DESIGN & ACCESS STATEMENT ADDENDUM  
JULY 2020

20-24a  
POPE'S  
ROAD

This Design & Access Statement Addendum has been prepared to form part of the 20 - 24A Pope's Road planning application addendum and should be read in conjunction with the remainder of the planning documentation.

Fig. 2.1.1.2 July 2020 Planning Addendum site plan

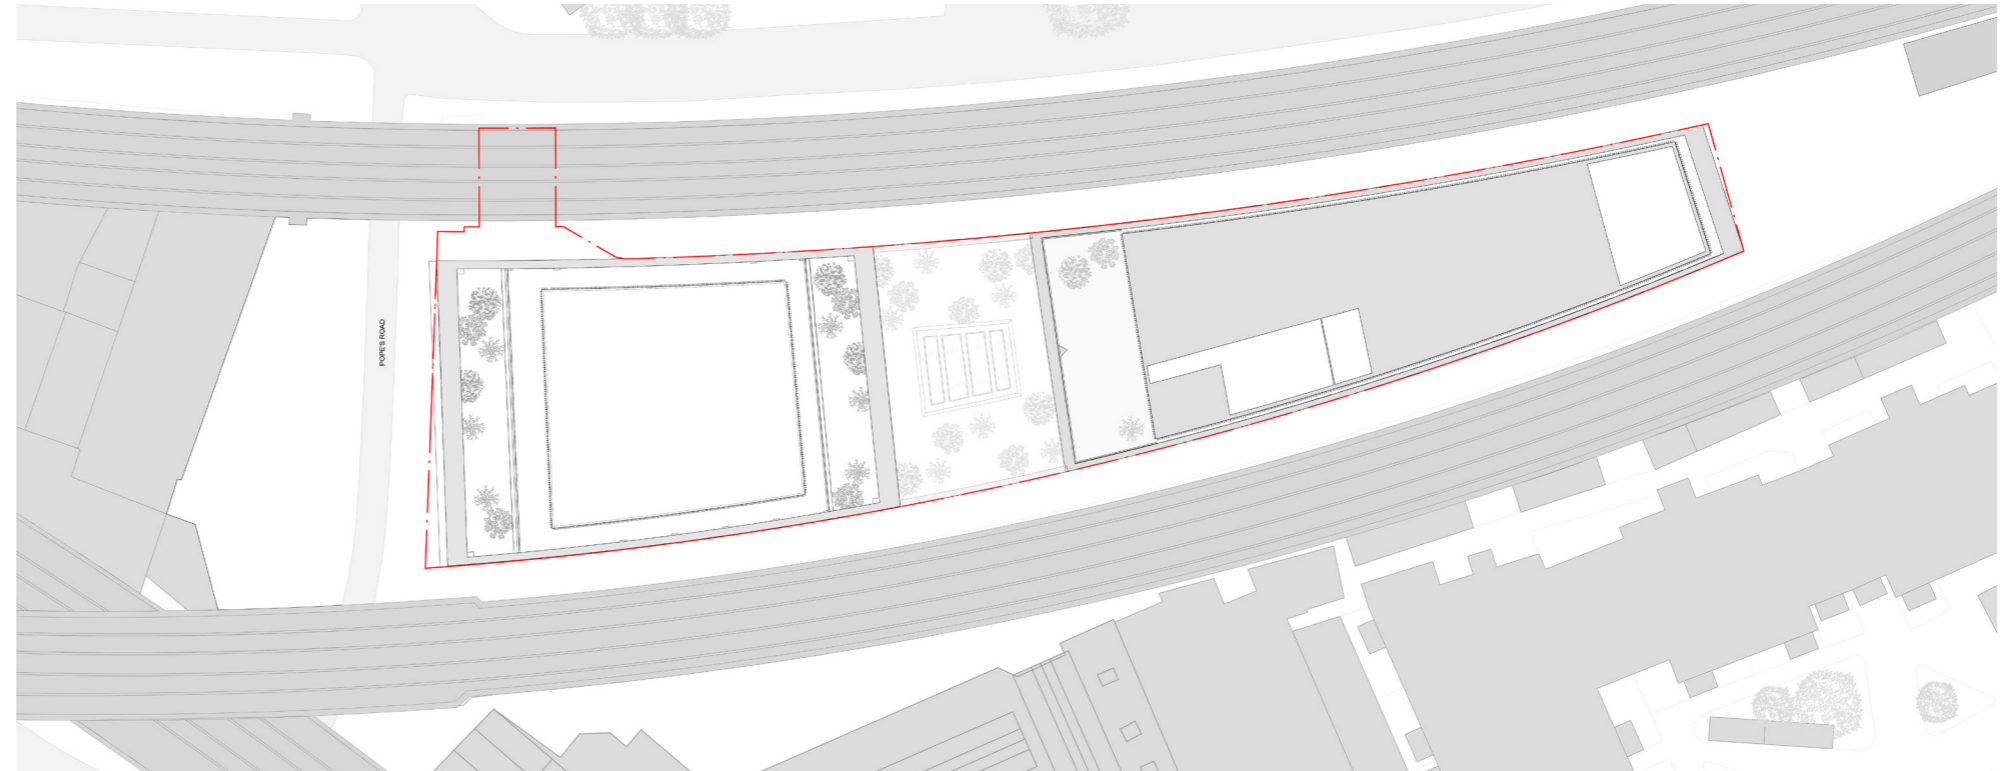
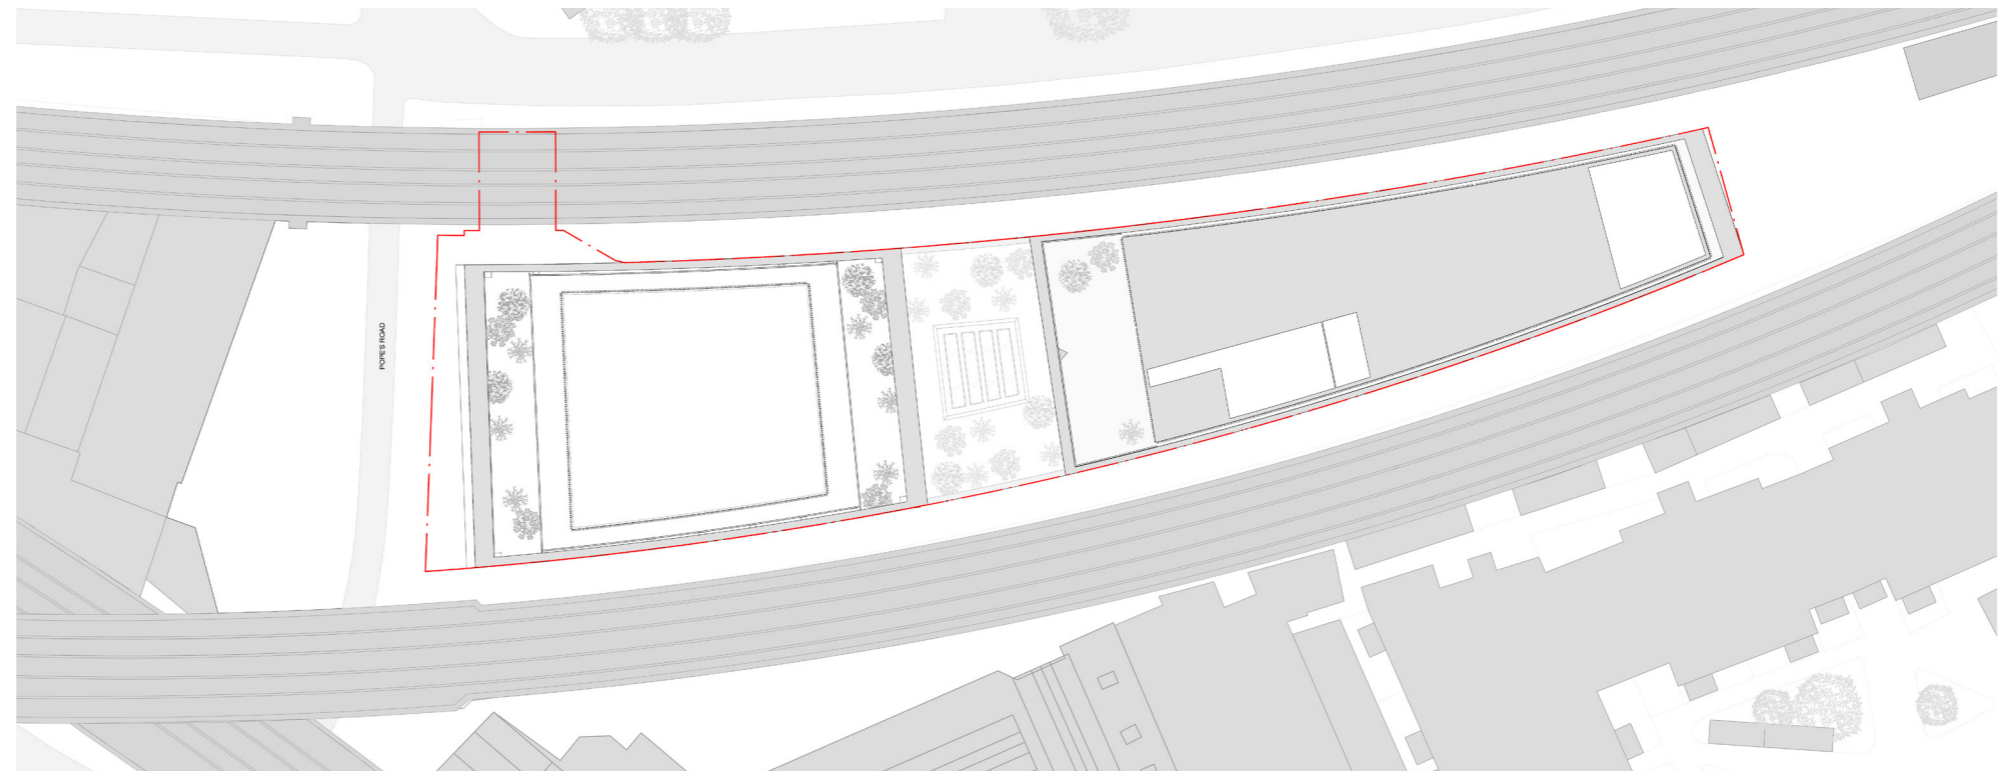
The current proposal incorporates a re-alignment of the building on the West side of the site facing Pope's Road by moving the West block 2.5m eastward.

Moving the West block eastward 2.5 m facilitate additional public realm on Pope's Road giving the already enhanced public square some additional breathing space.

Fig. 2.1.1.8 July 2020 Planning Addendum typical office floor plan

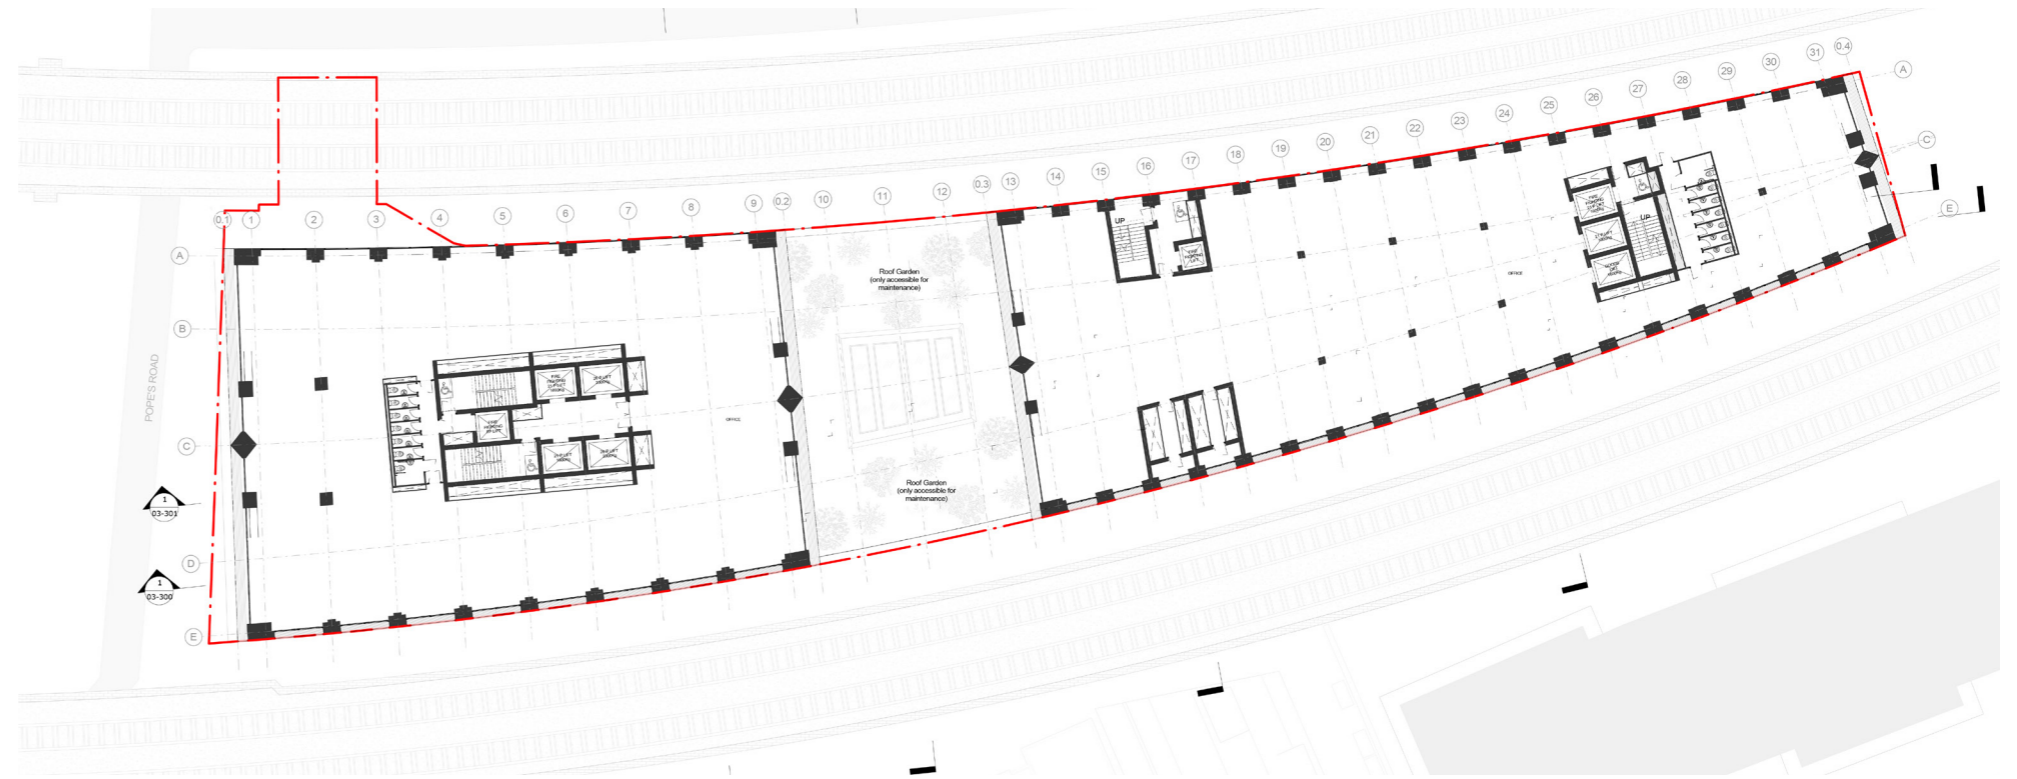
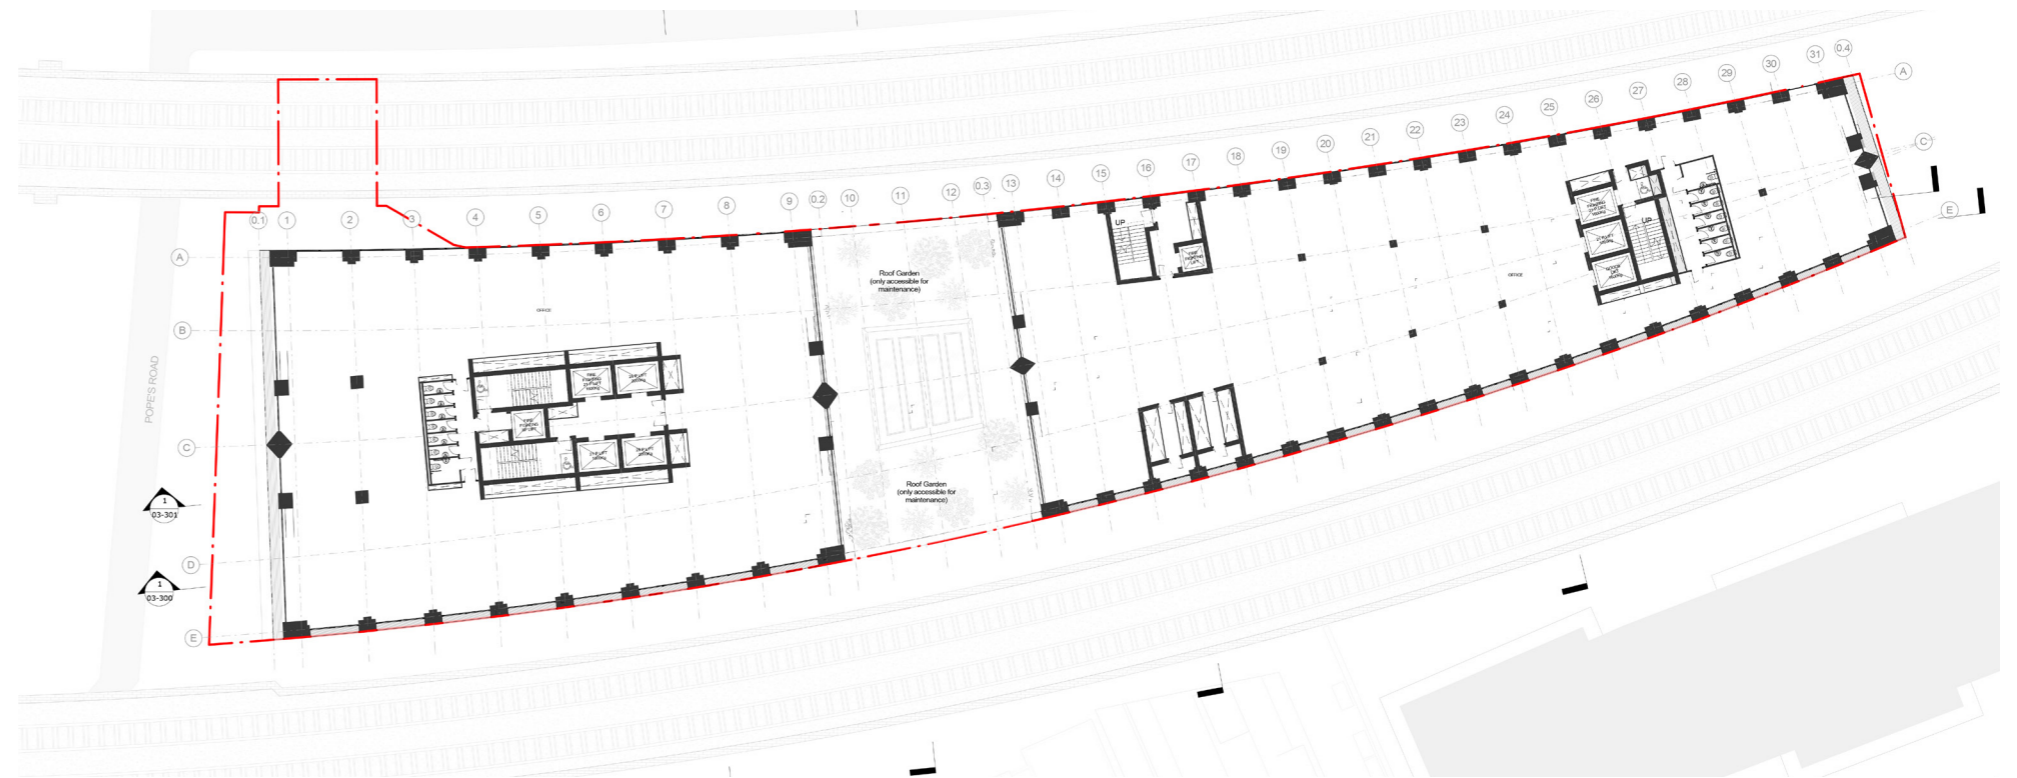
Due to the repositioning of the West block and the tapering of the site, the floor plates of the West block are reduced and altered.

Due to the amendments proposed, the dimensions and area of the central block which requires adjustments and repositioning of a number of design elements, including the central void, the skylight, the structural grid and facade modulation.

Fig. 2.1.2.4 July 2020 Planning Addendum illustrative perspective longitudinal section

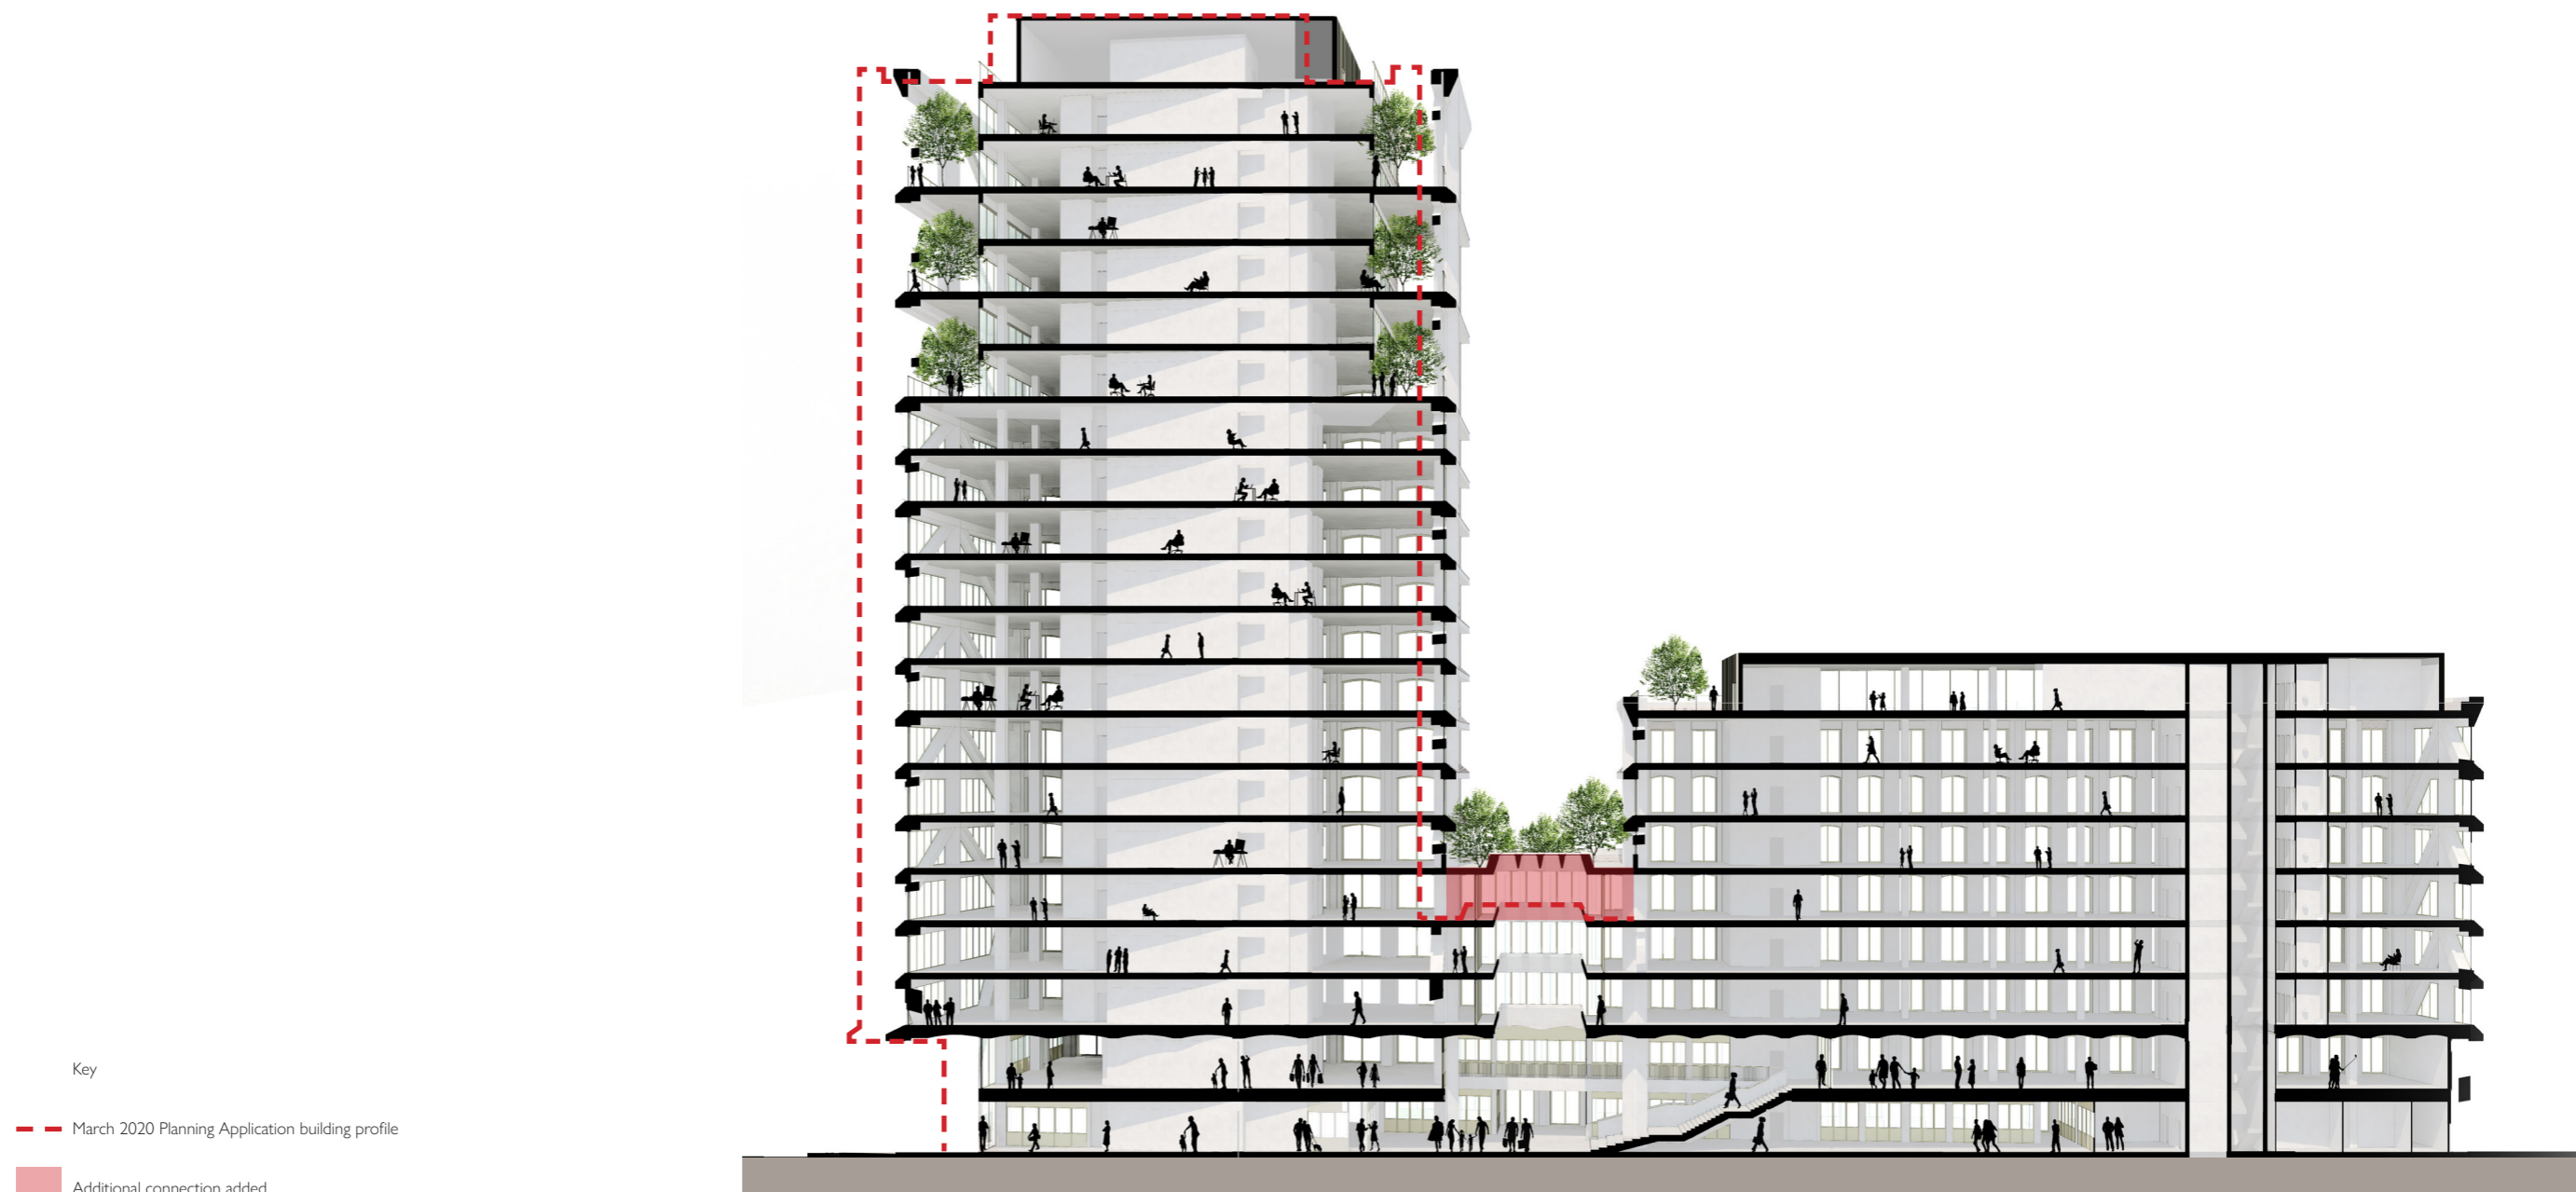
The addition of a linkage between the West and the East block at fourth floor generates the uplift of the skylight and of the void over the publicly accessible open space of one floor.

In addition, because of the reduced floorplate of the central block the dimensions and positioning of the skylight have been revised.

This design adjustment augments the interactions between office spaces and the market whilst increasing verticality and the spatial quality of the space.
